## Watts Bar Nuclear Plant (WBN)

Pre-Submittal Meeting for Non-Voluntary License Amendment Request (LAR) to Correct Unbalanced Voltage Relay Instrumentation Values

October 10, 2019

### **Correct Instrument Values**

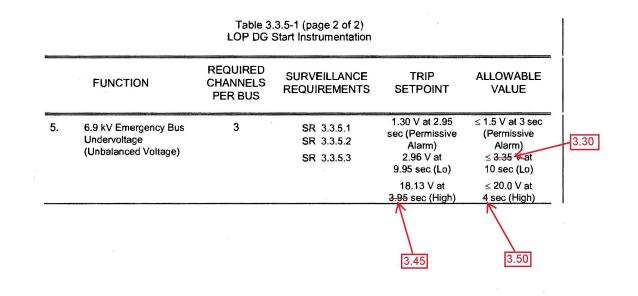
Function 5 Parameter	Value as Approved by NRC	Correct Value	
Trip Setpoint (High)	3.95 second (sec)	3.45 sec	
Allowable Value (AV) Lo	≤ 3.35 volts (V)	≤ 3.30V	
AV High	4.0 sec	3.50 sec

- The correct values are supported by the TVA undervoltage relay (UVR) calculation that was in effect at the time the LAR was submitted.
- The LAR will contain information to demonstrate how the correct values were obtained.
- If the license amendment was implemented as approved by NRC, the trip setpoint (High) would exceed the actual AV (High).
  - This would make the channel immediately inoperable
